STANDARDS & SPECIFICATIONS SITE INSPECTION REPORT LEVEL 1 (FIELD REPORT)

Project Name:	Mountain Valley Pipeline	S&S Program:	Mountain Valley Pipeline (SS027)
Inspector:	Marshall Willis	Inspection Date:	Thursday, March 27, 2025
Project Contact:	Cory Chalmers Brian Clauto	Project Contact Email:	Cory.chalmers@eqt.com Brian.clauto@eqt.com
Spread H: Montgomery County	STA 12416+00 – 12483+00 MVP-MN279/279.01 MVP-MLV-AR-28	Site Conditions:	Dry

Fig. 2

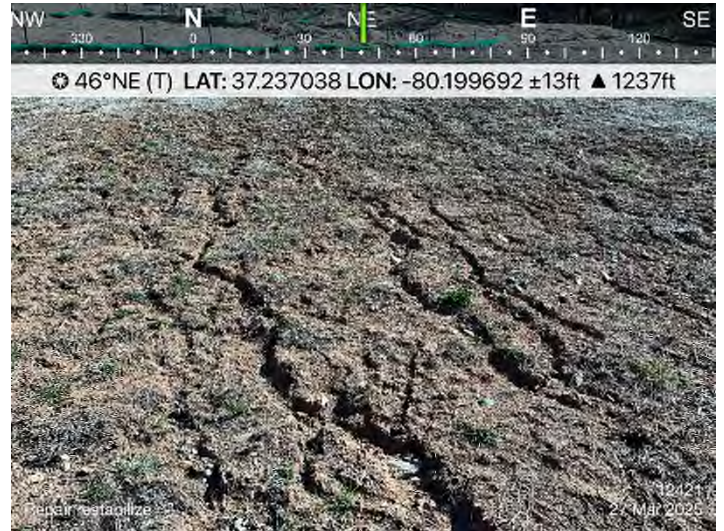
STA 12420+00 to 12421+00: Repair and restabilize denuded areas.
